X-300 firmware version cMT2078X-3.03

Firmware release notes

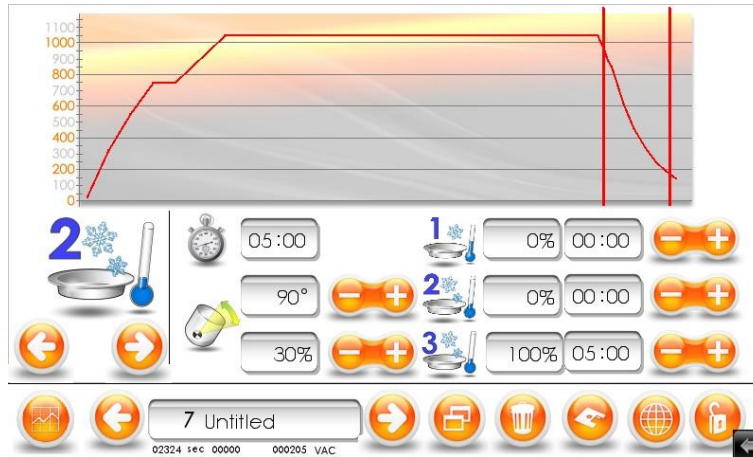
- New "Data Sampling" feature added. It gives the ability to log every fusion cycle with the samples IDs and generate a separate report for each day, up to a possibility of 40 days data recovery.

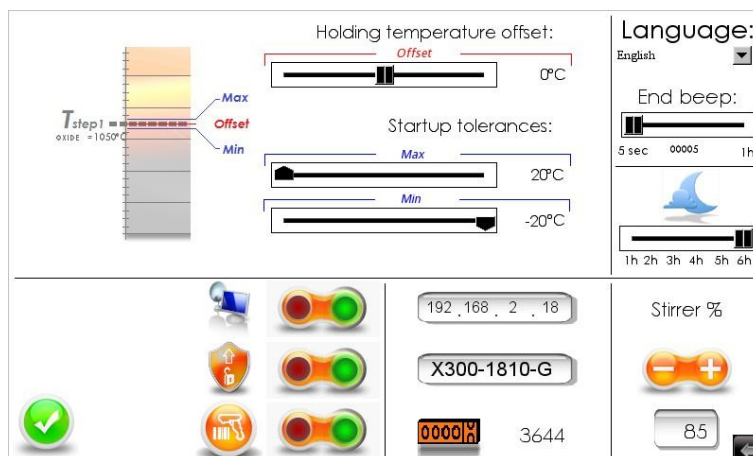
- New information fields, showing the serial number of the unit and the fusion counter in the global parameter window.

- Various labels in the global parameter window have been replaced by icons in order to reduce the amount of text. The "security shield" and the "moon crescent" icons are linked with the same feature as before (i.e. activating/deactivating the security shield in order to start a fusion, and setting the delay for an automatic shutdown to occur, respectively).
